Subject: MHI's Responses to US-APWR DCD RAI No. COLP 342-2526 Revision 0

Reference: 1) "Request for Additional Information No. COLP 342-2526 Revision 0,
SRP Section: 18 - Human Factors Engineering, Application Section:
18.4 Task Analysis," dated April 23th, 2009.

US-APWR Design Certification

RAI NO.: NO. COLP 342-2526 REVISION 0
SRP SECTION: 18 - HUMAN FACTORS ENGINEERING
APPLICATION SECTION: 18.4 TASK ANALYSIS
DATE OF RAI ISSUE: 4/23/2009

Figure 18.1-3 Operations Personnel Staffing and Organization (Typical)

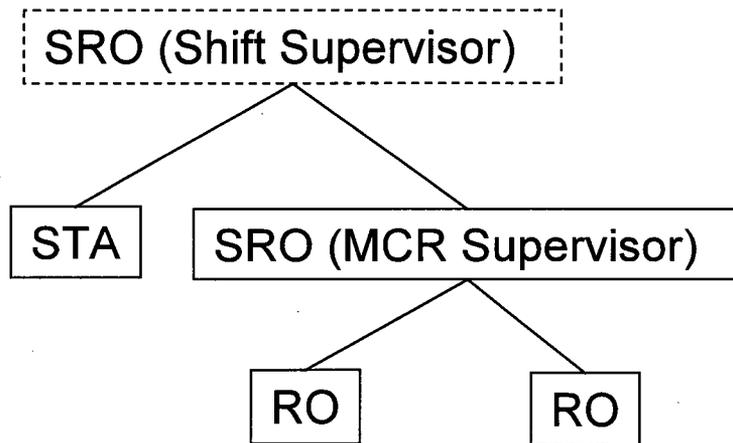
Criterion 1 of Section 6.4, "Staffing and Qualifications" states that staffing and qualifications should be address applicable guidance in 10 CFR 50.54. the regulations found in 10 CFR 50.54(4)(m)(2)(iii) contains requirements that there be at least 2 licensed operators in each unit during normal operations. It is not clear from the documents submitted that the US APWR control has been designed for 2-operator operation. Please explain how the task analysis for the US APWR plans to address the difference between the single-operator APWR and the required minimum of 2 operator US APWR.

one RO continuously in the MCR . Therefore, the HSI design considers the minimum continuous MCR staffing shown in Figure 5.5-1, and the maximum continuous MCR staffing shown in Figure 5.5-2. It is noted that Figure 5.5-2 of MUAP-07007 and Figure 18.1-3 of the US-APWR DCD will be revised to eliminate the words "Not located in MCR". Since the task analysis is intended to address the worst task burden situations, the analysis only considers the single RO staffing condition. The two RO staffing condition was tested for various plant scenarios during Phase 1a V&V; there were no HEDs that related to the two RO staffing condition. Therefore, additional two RO staffing scenarios were not conducted in Phase 1b V&V, and are not planned for Phase 2 V&V.

The Figure 18.1-3 of DCD subsection 18.1 will be revised to eliminate the words "Not located in MCR".

The Attachment 1 page 18.1-16 shows the above change.
